**Subject: BMW Recall 21V-xxx: Outer Headrest Second Row - Update**

SIB 52 04 21

## RECALL 21V-XXX : OUTER HEADREST SECOND ROW

This Service Information Bulletin (Revision 2) replaces SI B52 04 21 **dated March 2021**.

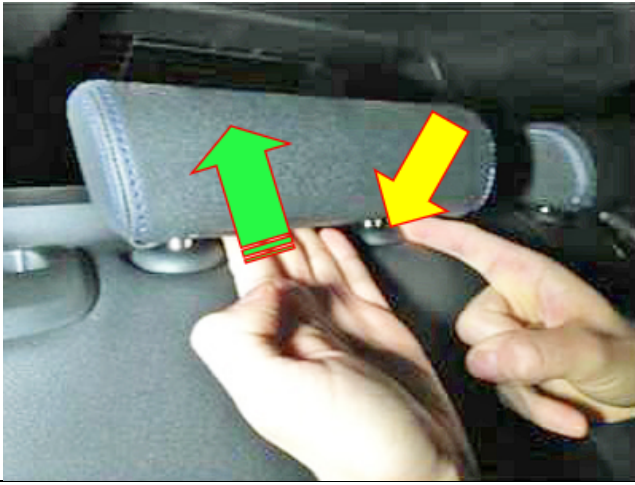
Left and right outer headrests may have been installed which do not have a positive stop movement limiter at their highest position. During a frontal impact, unsecured items (e.g., luggage) in the rear could move forward and contact the rear seat, which could cause the headrest to detach from the seat.

1. On either outer headrest, squeeze the headrest height release button (yellow arrow) at the seatback top retaining collar.

b. Carefully check if the headrest post has 5 notches (circled).

- If 5 notches are present AND the headrest cannot be lifted out of the backrest, the headrest is OK and does not need to be replaced.
- If there are only 4 notches, OR the headrest CAN be lifted out of the backrest, the headrest is NOT OK and needs to be replaced.

Check each headrest for the presence of the positive stop. If missing, replace the headrest.
